State Significant Development – Glanmire Solar Farm (SSD-2128499)

I refer to the above project and the Environmental Impact Statement (EIS) currently on public exhibition.

Council has had an opportunity to review the EIS as submitted and provides the following comments as to the matters contained within.

3.0 Concept Plan

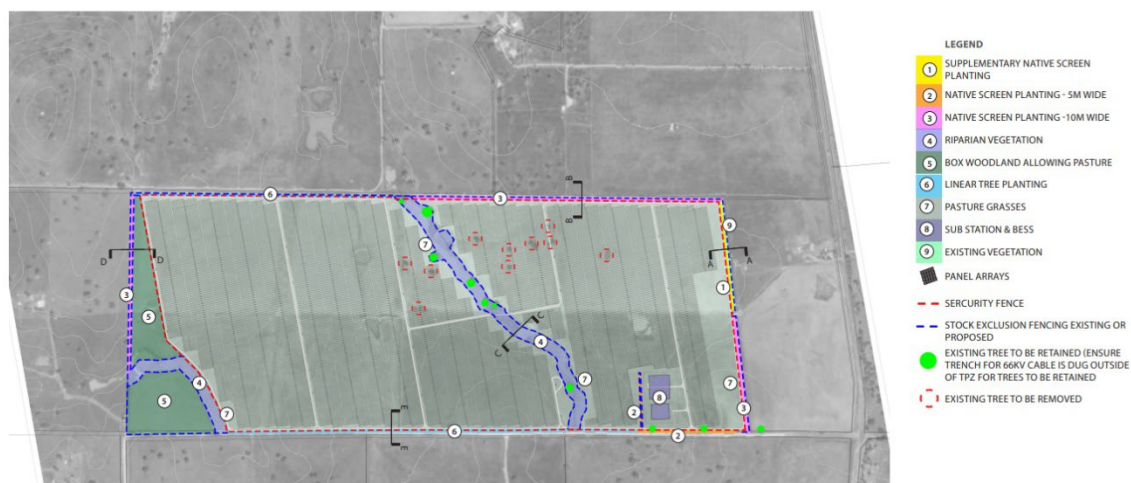
It is noted that planting is proposed around the perimeter of the site and throughout the riparian corridor.

However, photomontages of the site suggest that the solar farm could be a prominent feature within the landscape and the gateway to the city during the short to medium term, as the vegetation is established and matures onsite.
